BERRYS BAY STUDIO

Objection: SSD-93020230

40 – 48 Redan St, MOSMAN

On behalf of Neighbouring Residents

Figure 5 - Site Analysis – fails to recognise views from neighbouring properties

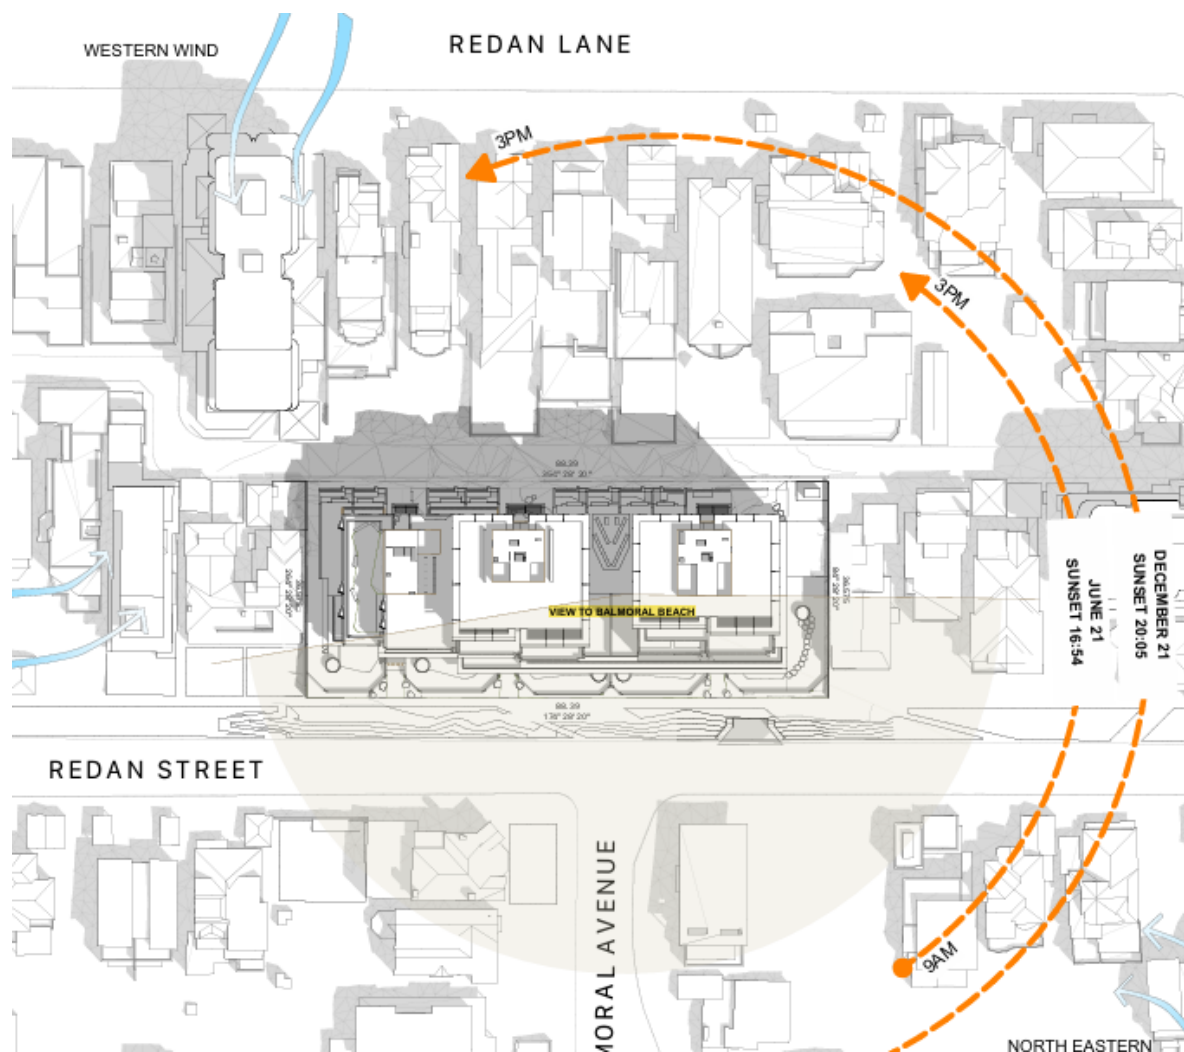
Visual Impact Assessment

- a. The Visual Impact Assessment by Urbis on behalf of the applicant, fails to provide any photomontages of the proposal to assess view loss from housing to the west of the site on Muston Street and Redan Lane as identified above.
- b. It also fails to address visual impact of the development on the outlook from these affected properties, noting it will largely dominate the skyline, having an unsympathetic intrusive effect on their outlook.
- c. The Site Analysis at Figure 5 below acknowledges 'View to Balmoral Beach' (highlighted below) which are enjoyed from existing housing at the site and will be enjoyed by future residents, however it fails to acknowledge these views are common to most housing along Redan Lane and Muston Street to the western rear, and will be largely blocked as a result of the proposed development.

A more skilful and sympathetic medium density housing design could be achieved over the site with significantly lowered building height that maintains reasonable view sharing and sunlight access.

At the very least, the applicant should be required to erect height poles on the site to allow for neighbours, Council and the assessment officer to clearly see the impacts on adjacent properties in terms of height, visual impact, overshadowing and view loss.
